MIL-D-70789A (AR)
 AMENDMENT 2
~~09 November 1994~~
 SUPERSEDING
 AMENDMENT 1
 14 April 1993

MILITARY SPECIFICATION

DYNAMIC REFERENCE UNIT (DRU)

Figure 11
ESS Temperature Cycle

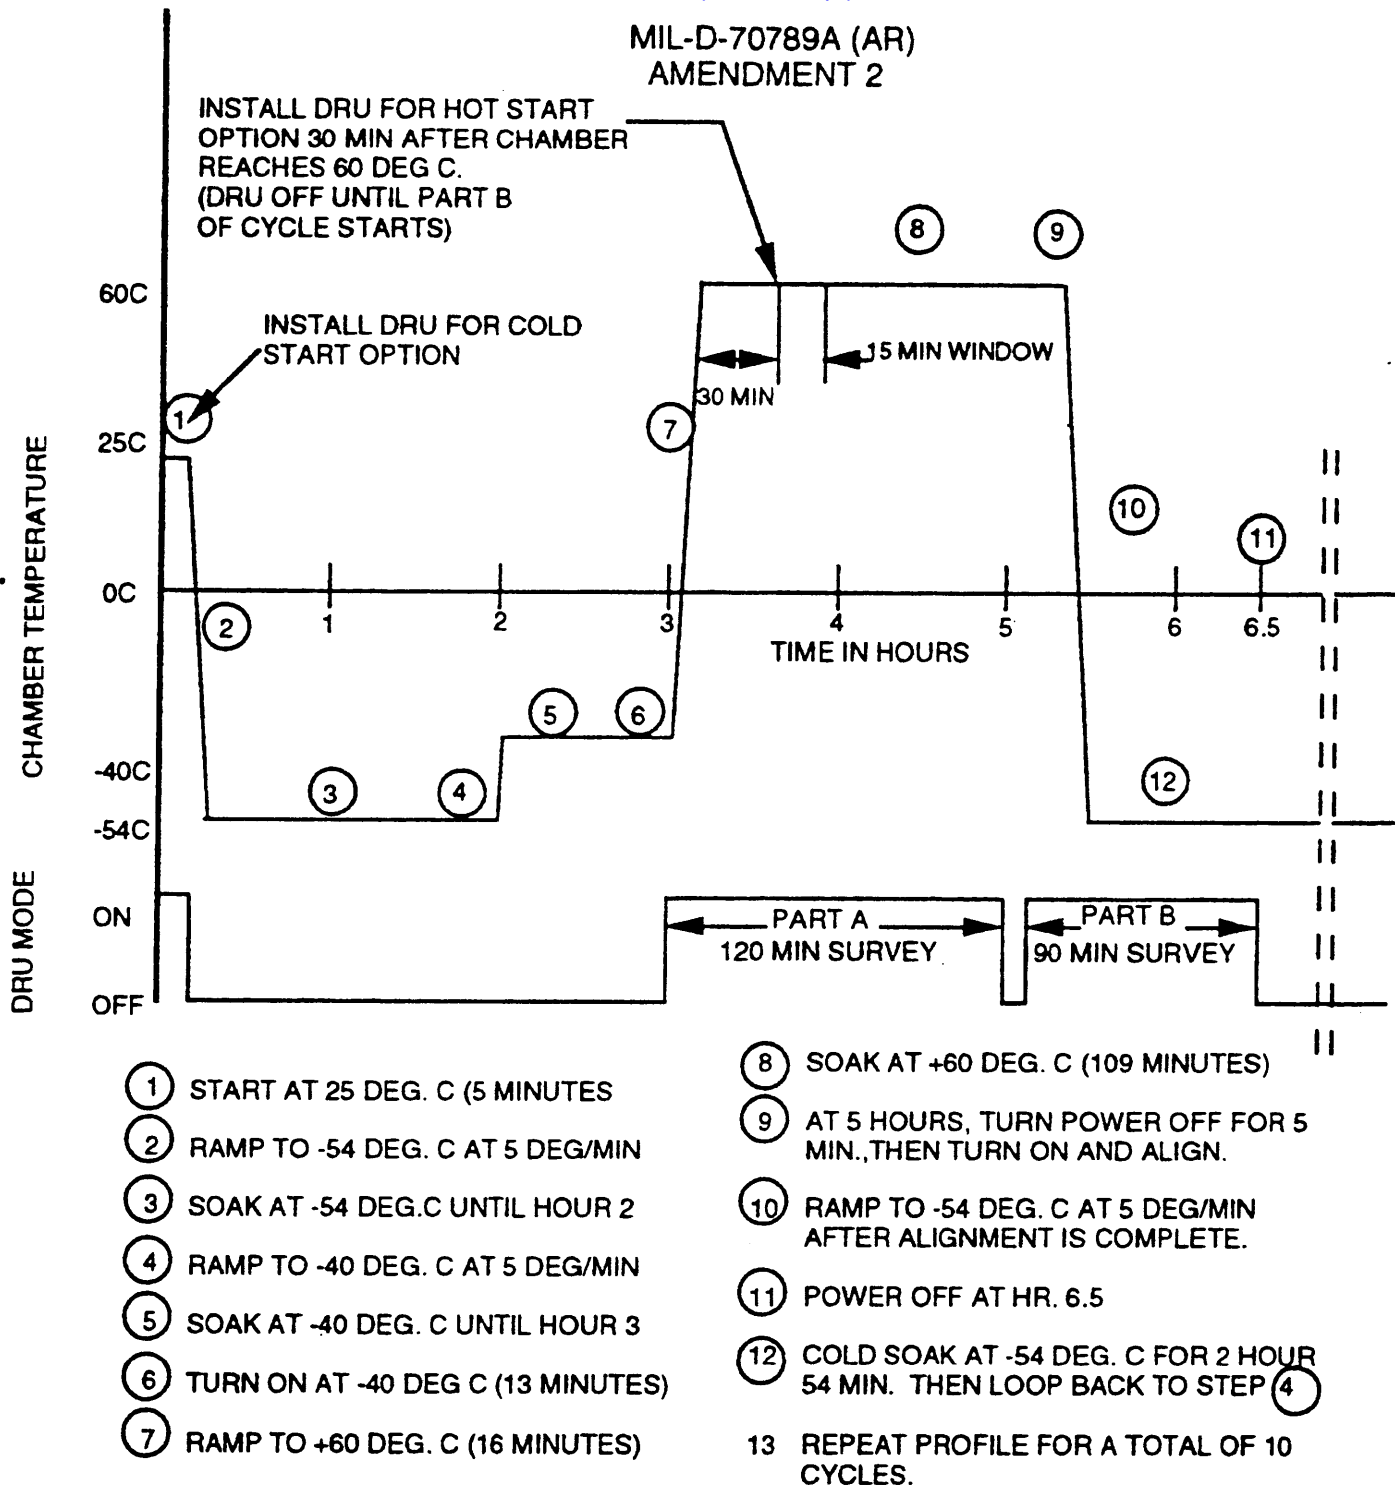
Figure 11, Temperature Cycling: Delete in its entirety and substitute as included page 67.
